MBCA

November 16, 2018

Reference: Ord Mountain Solar and Energy Project Draft Environmental Impact Report (EIR)
October 2018 SCH No. 2017051082 Lead Agency: County of San Bernardino (County)

Exhibit 6: The Combined Visual Impacts of the Existing and Proposed Utility-Scale Solar Projects

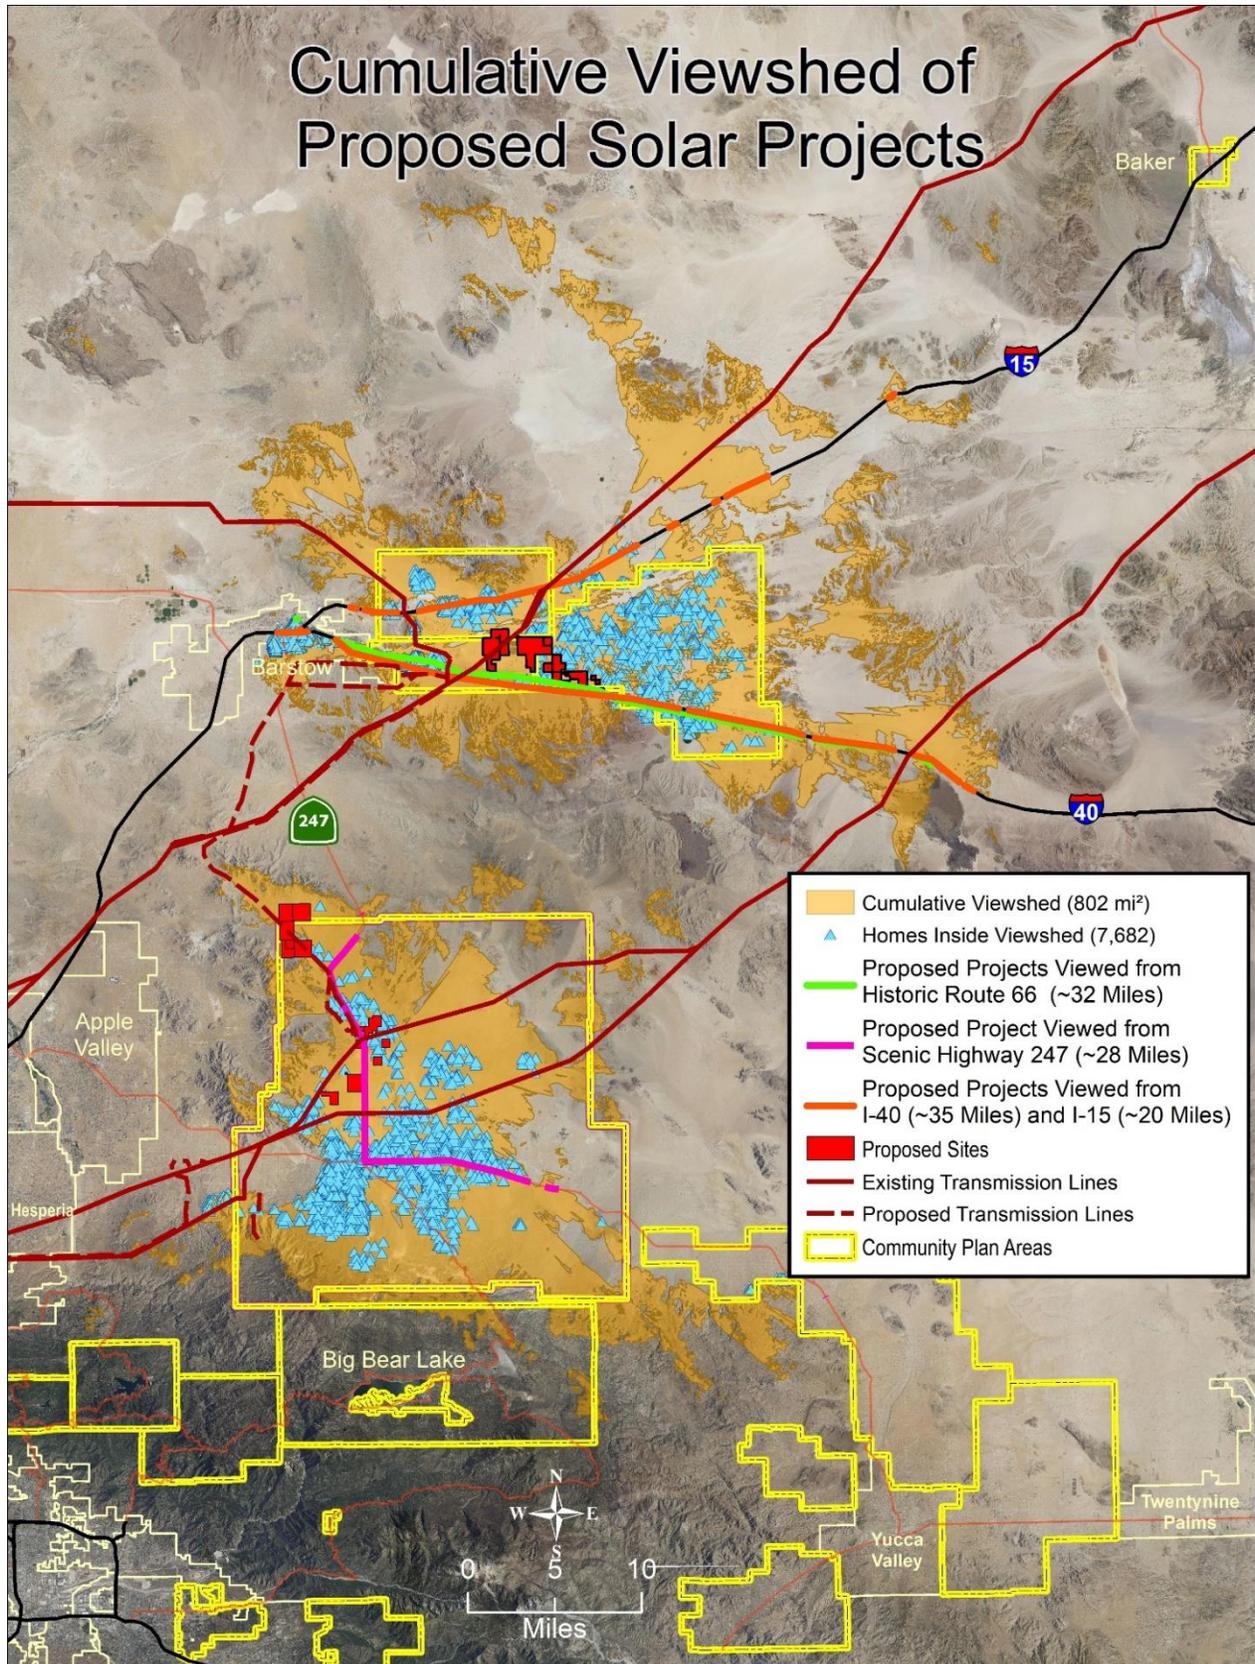
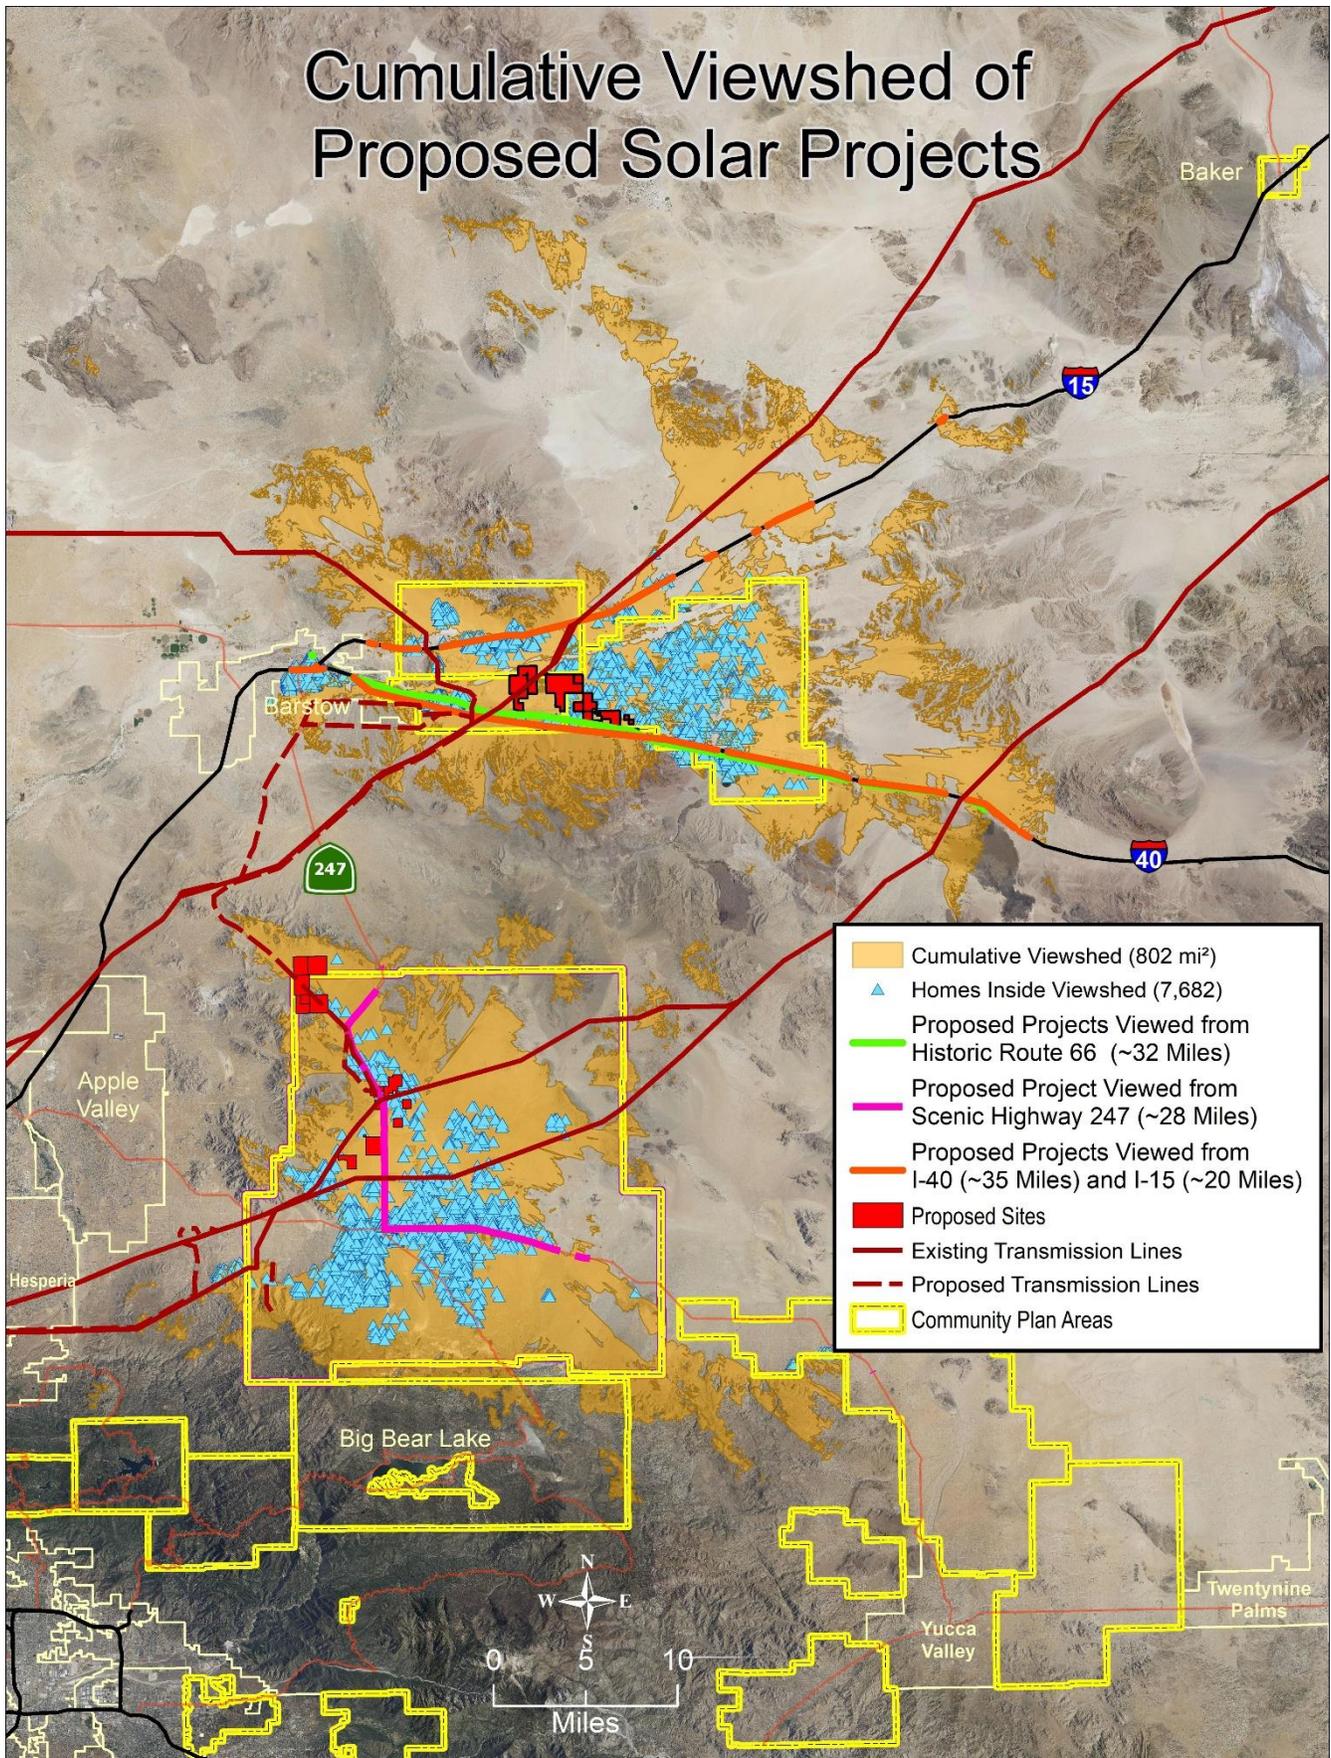
The Cumulative Projects viewshed (Exhibit 6) multiplies the visual impact. The total area of visibility is over 800 square miles. The combined visual impact will be seen by over 7,700 homes and the 17,000 +people that live there. Scenic natural desert and desert community views from Historic Route 66, and Interstate Highways 15 and 40 will be replaced with a sea of solar arrays.

10,000 people will wake up and walk outside their homes in the morning and see one of more of these existing and proposed projects if they are built. The number of tourists on the four County Scenic Highways is not known – but it will be significant until they decide to choose other less encumbered scenic routes.

- The Proposed Projects will cover 17 square miles
- The Proposed Projects will be seen from 800 square miles
- 4,400 homes are located inside the 4 desert Community Plan areas
- The Proposed Projects will be visible from 4,000 homes
- The Proposed Projects will be visible to 90% of the homes in the Community Plan areas
- Tourists from all over our nation and the world will drive down Historic Route 66 and see the Proposed Projects for 32 miles
- Tourists will drive down Scenic Highway 247 and see the Proposed Projects for 28 miles. That's over 1/3 of the Scenic Highway.

Exhibit 8: Granite Mountain Wind Speed and Direction

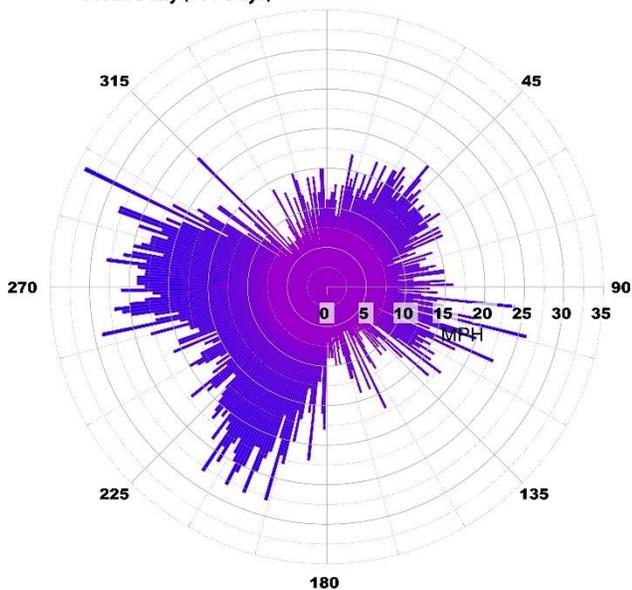
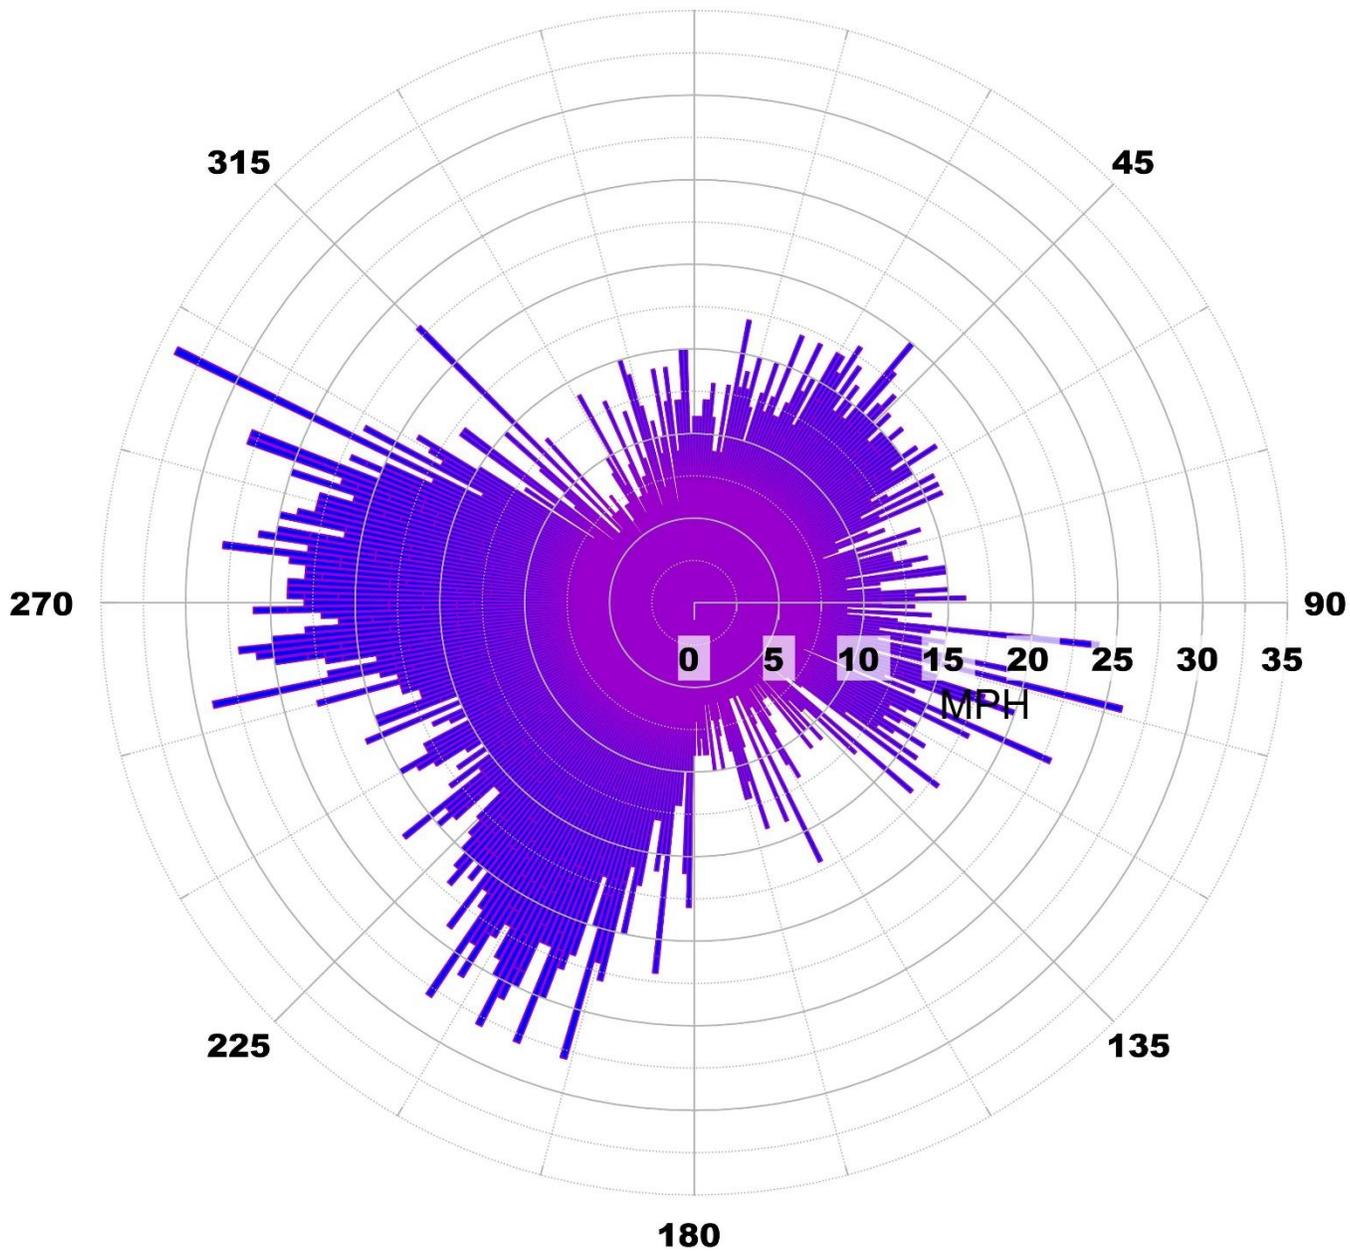
River Valley locations except for those few times when the wind comes in from the east. The prevailing winds are from the South Southwest - see Exhibits 8 and 9.

Exhibit 10: Ord Mountain Solar Project and Calcite Substation showing the Hazard of Blowing Soil and Dust with Vegetation Communities

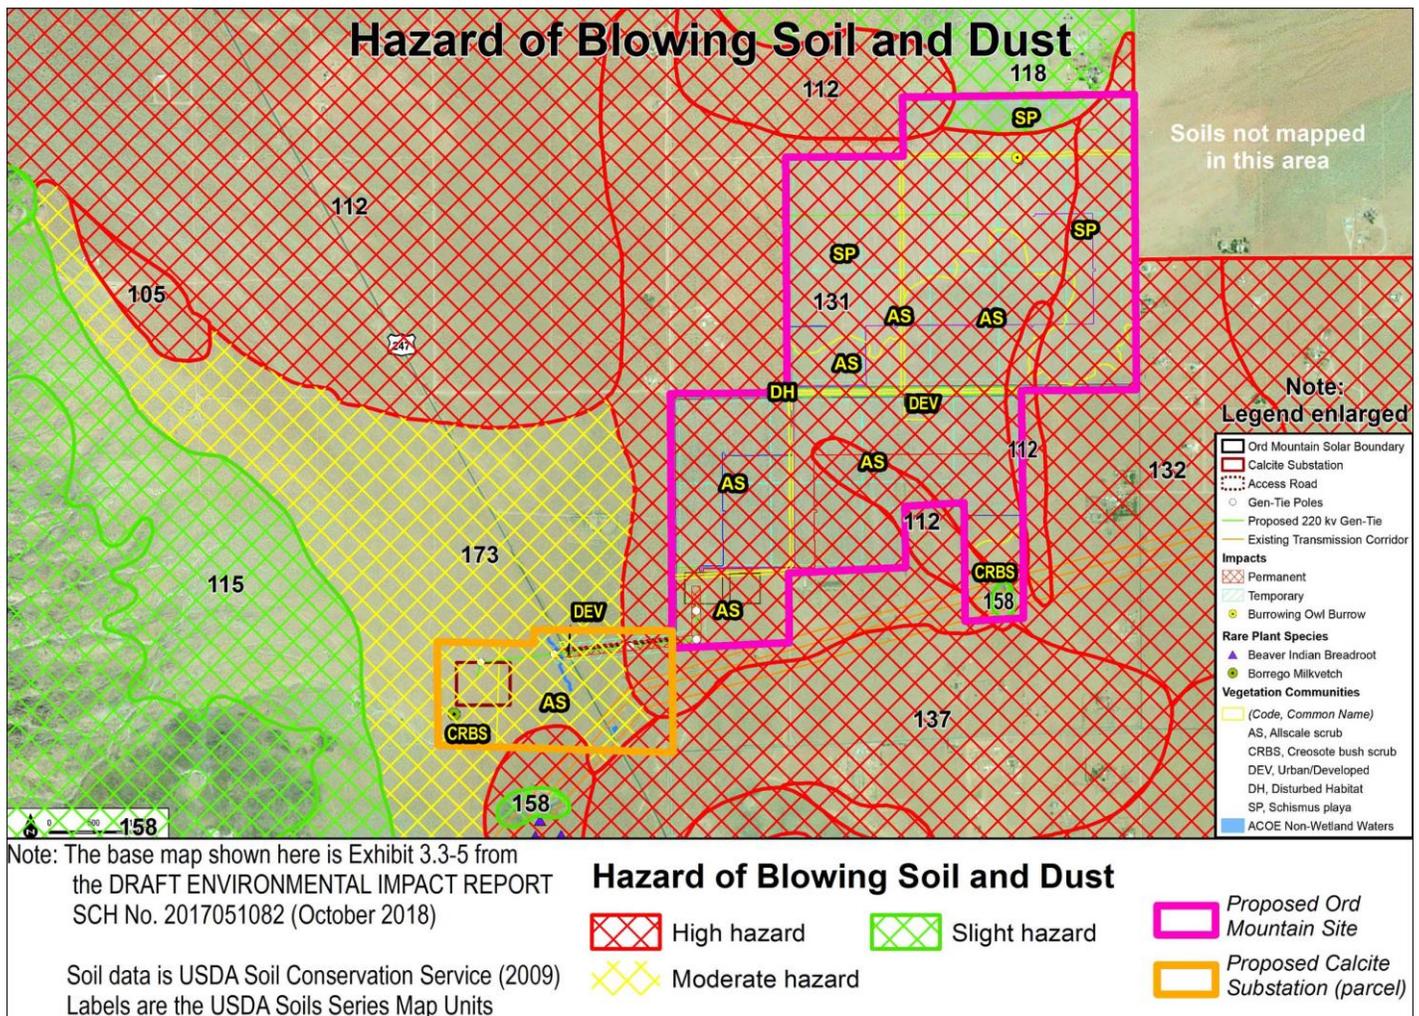
An important mitigation for all projects in the Lucerne Valley and Mojave River Valley would be to stop work during the Spring months when the winds blow the hardest.

Exhibit 10, using NRCS soils data, displays the high, moderate, and slight hazard of blowing soil and dust as well as the three Vegetation Communities mapped on the project. As discussed above, we are in agreement with the Vegetation Communities data and mapping provided in the EIR Biological Resources Section 3.3. See Exhibit 2, this report and Biological Resources Table 3.3-1 (page 3.3-3) and the Vegetation Communities map Exhibit 3.3-1 (page 3.3-5)

Exhibit 11: Blockage of the North Valley Desert Linkage Corridor

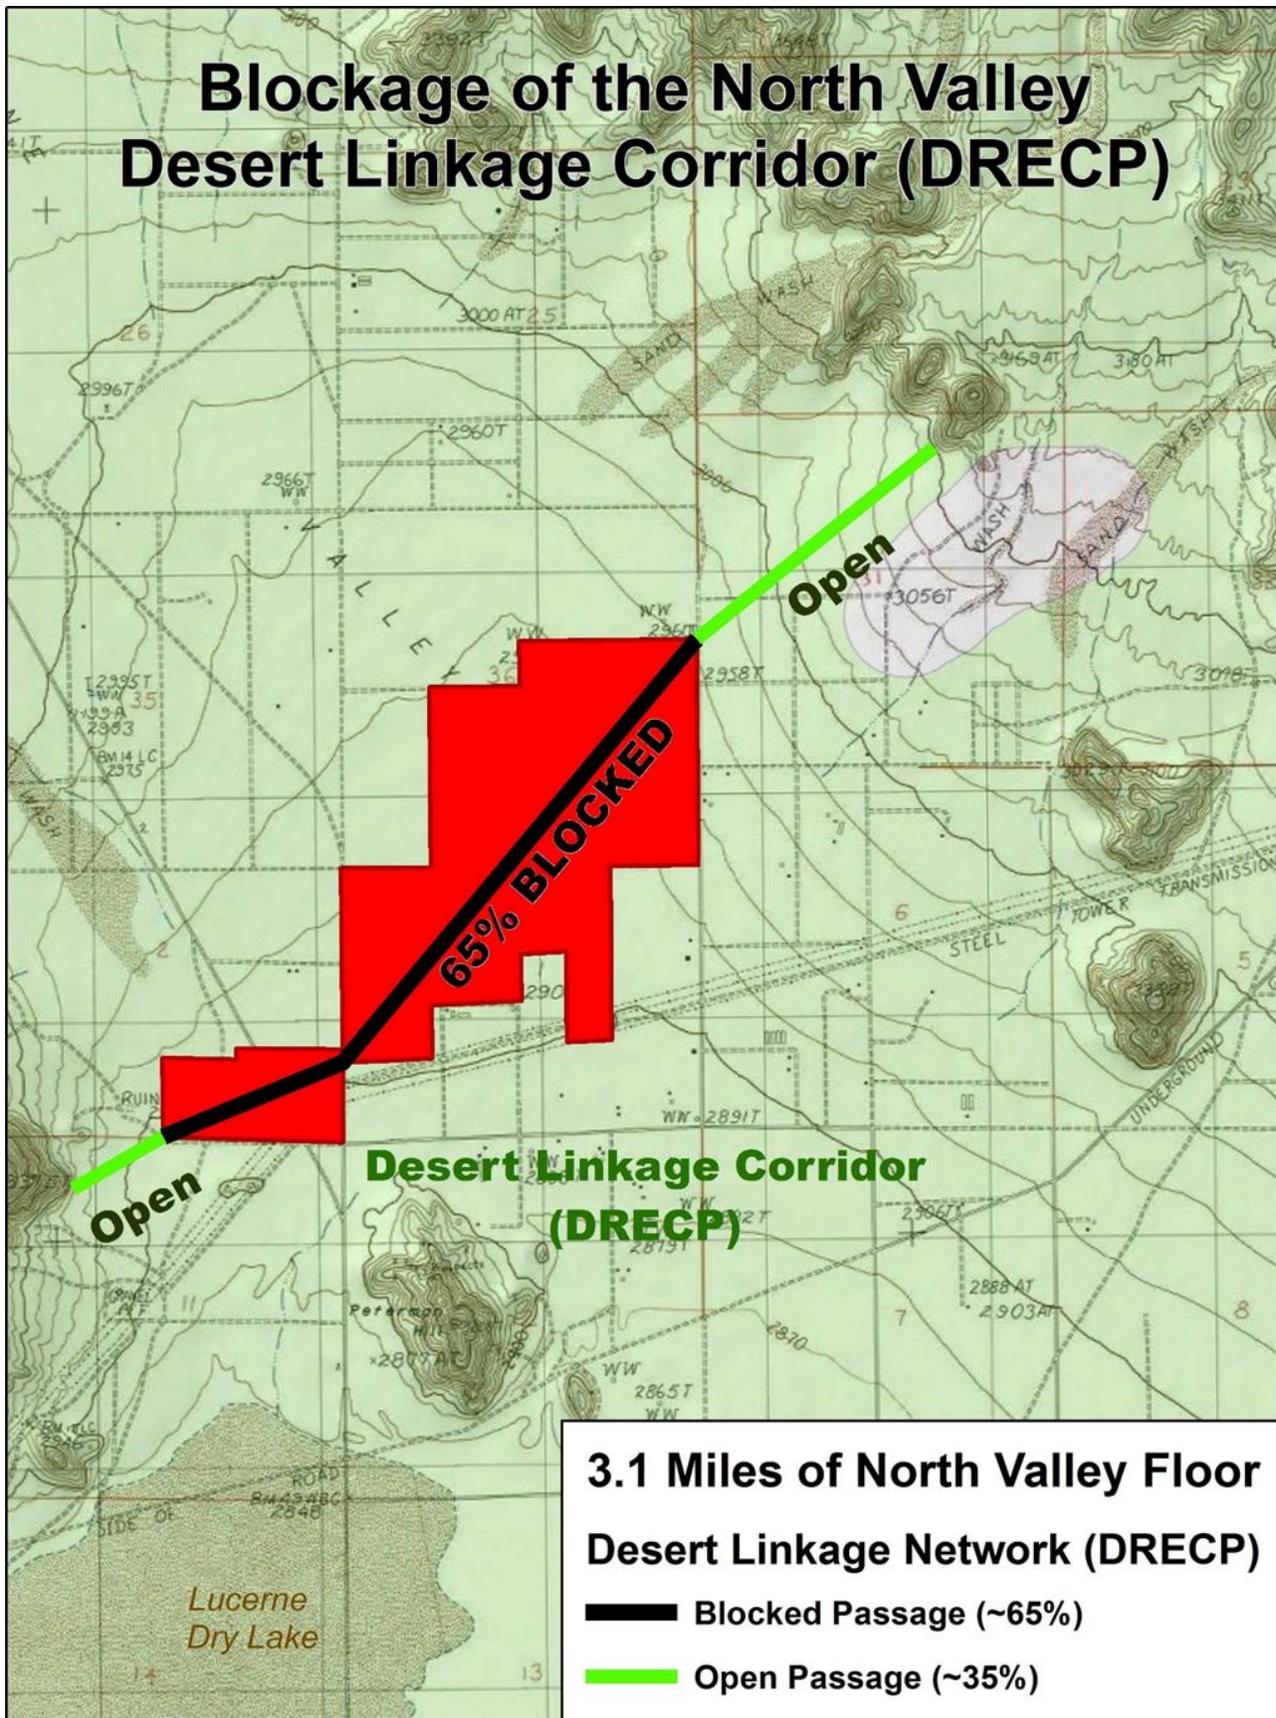
We accept this definition but take complete exception to the preceding sentence *“The main prerequisite for corridors is that they increase animal movement between habitat patches.”*
